Local Planning Panel

191-195, 197-199, 201 Oxford Street, Darlinghurst

D/2022/327

Proposal

proposed - north elevation

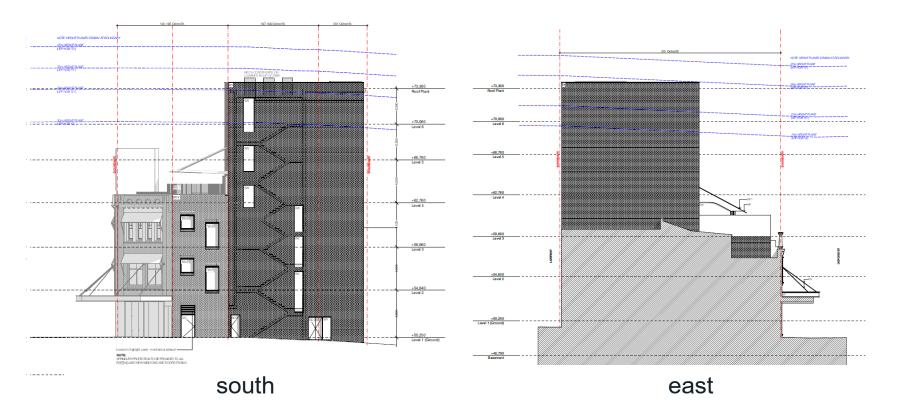
- standard maximum height: 12m
- alternative maximum height: 20m
- proposed height of 24.8m
- clause 4.6 does not allow variation to the alternative height
- therefore 12.8m (106.7%) variation to the standard height
- clause 4.6 variation request not supported
- fails to demonstrate that compliance is unreasonable or unnecessary and that there are sufficient environmental planning grounds
